APPENDIX 2 - STATEMENT OF CONSULTATION ON PALMER PARK DEVELOPMENT FRAMEWORK

1.0 SUMMARY OF CONSULTATION

2.0 READING BOROUGH COUNCIL NATURAL ENVIRONMENT OFFICER AND HERITAGE
CONSULTANT COMMENTS

FIGURE 1: ILLUSTRATIVE MASSING PLAN - EXISTING (POOL BUILDING OPT 1)

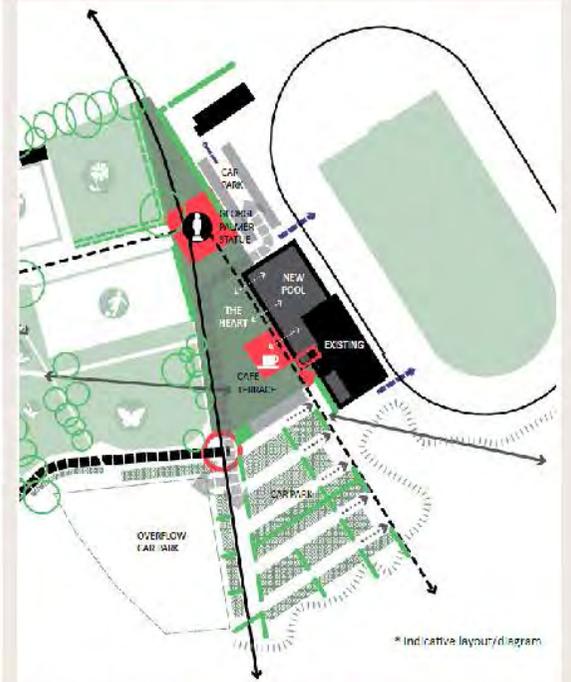
- **Support for Option 1** (raised by 22 respondents)—Respondents found Option 1 to be the most aesthetically pleasing and found it less intrusive than Option 2. Some noted that it best facilitated pedestrian flows, with the entrance visible and accessible for park users either on foot or by car.

Comment	Changes made to the document
The proposals are not considered to have any adverse impacts on the setting of designated heritage assets.	Noted. No change required.
The aspiration to improve the setting of the George Palmer statue requires careful detail, but should serve to prove an overall heritage benefit.	Noted. No change required. Detailed proposals' effects will be assessed at application stage.
The proposal for the car park to the southern end of the park also requires careful detailing in order to respect the character of the adjacent piers and gates within the entrance.	Noted. No change required. Detailed proposals' effects will be assessed at application stage.
The designs for the swimming pool building are both modern designs which is considered appropriate within the context of the Stadium and surrounding infrastructure. Whilst there is no objection to either of the proposed designs, Option 1 would be marginally preferable as it has the simplest overall form.	Noted. The final framework features Option 1 as the preferred option.

FIGURE 11. INDICATIVE MASTER PLAN EXTRACT (POOL BUILDING OPT 2)

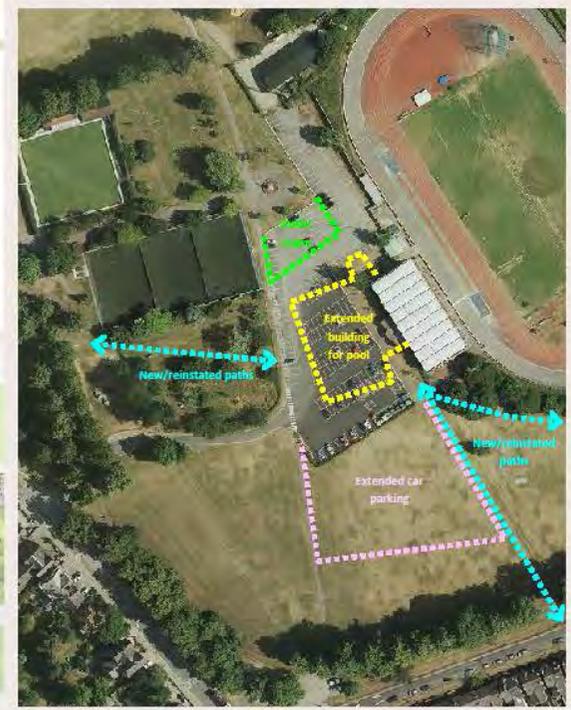
<ol style="list-style-type: none"> 2. We are pleased to see that the statue has been retained and the proposals for the enhancement of its setting. 3. The second option would have greater impact on the setting of the listed statue, but does provide the opportunity to place a building of landmark quality in a more central position in the park. HE have been interested to recognise the value of municipal building projects in developing outstanding architecture in the later 20th century. Chichester Festival Theatre is a good example of this. We recommend considering whether additional elements, such as the café to the north in option 2, would be better embraced within the structure to provide a more unified architectural scheme. 4. Option 1 would provide better integration with the existing sports facilities, framing the stadium space and would be less imposing in the parkland but could create a long frontage to the park that may be difficult to enliven along its entire length. 	<p>proposal aims to ensure that the new building reflects high-quality design principles and outstanding architecture. Specific design considerations will be addressed at application stage.</p> <ol style="list-style-type: none"> 4. Noted. Option 1 has been selected as the preferred option. The effects of the frontage will be addressed in detail at application.
